SERVICE BULLETIN

Service Bulletin No. / Date: SB TMG 125-1020 P1, Initial Issue / January 27, 2016

Subject: Gearbox Oil Leak Inspection

Type affected: TAE 125-02-99 and TAE 125-02-114

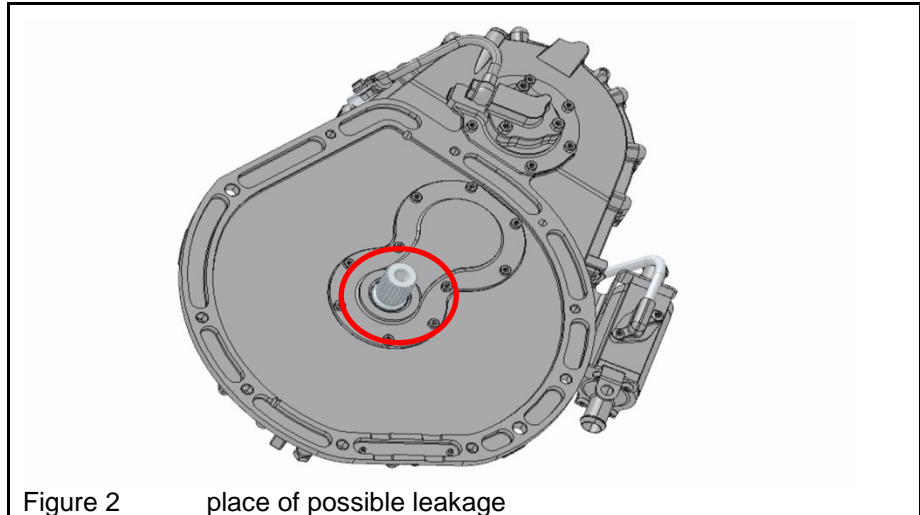
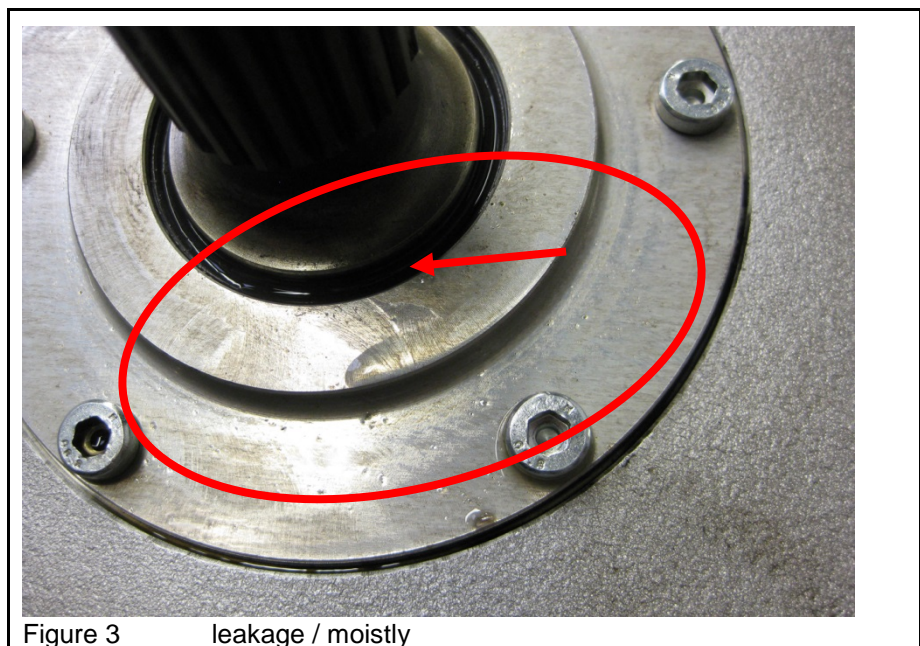
Reason: Radial shaft sealing ring may not seal properly due to an improper lapped gearbox drive shaft. This can lead to an oil leak and a slipping clutch and finally to a loss of power.

- Remove the gearbox and replace the clutch by dual mass flywheel in accordance with RM-02-02, Chapter 72-10.18, Issue 3, Revision - or later approved revisions.
- Inspect the gearbox, check the rear radial shaft sealing ring on the gear shaft for oil leakage and moisture, see Figure 2 and Figure 3.

- If there is a leakage or moisture, see Figure 3, replace the gearbox.
